### DETERMINATION OF NON-SIGNIFICANCE

**City of Bellevue  
Development Services Department  
Land Use Division Staff Report**

**Proposal Name:** JayMarc 113<sup>th</sup> Conservation Short Plat

**File Number:** 14-141426-LN

TREE RETENTION PLAN  
SHEET 4 OF 4

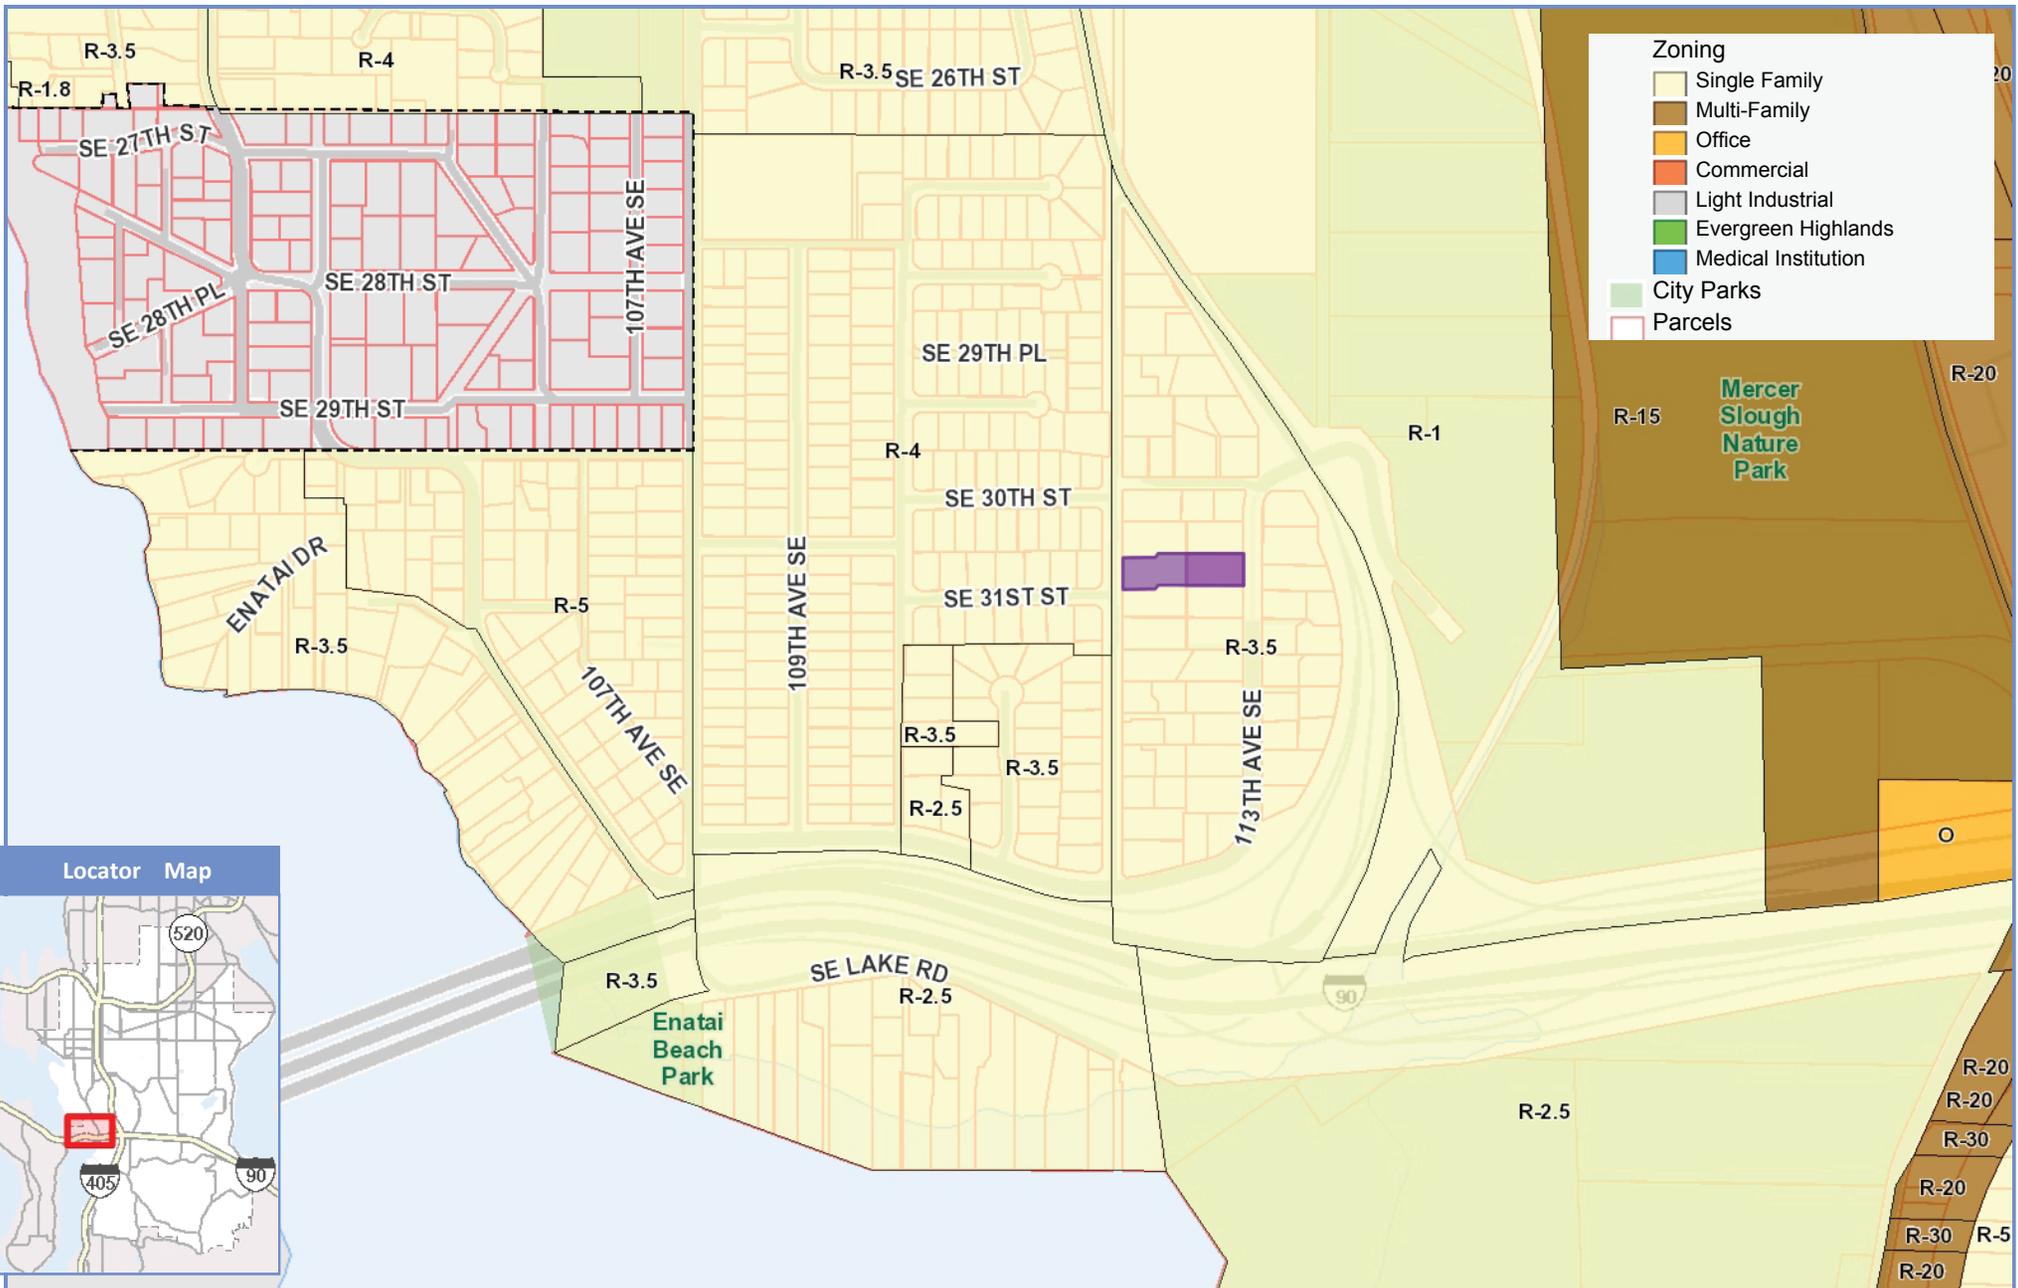
These trees are not on the subject property. They should not be included in the tree retention calculation.

When this sheet is prepared for Final Plat maps, only those trees that are to be retained should be shown on this sheet.

Corrected total, this does not include trees not on the subject property.
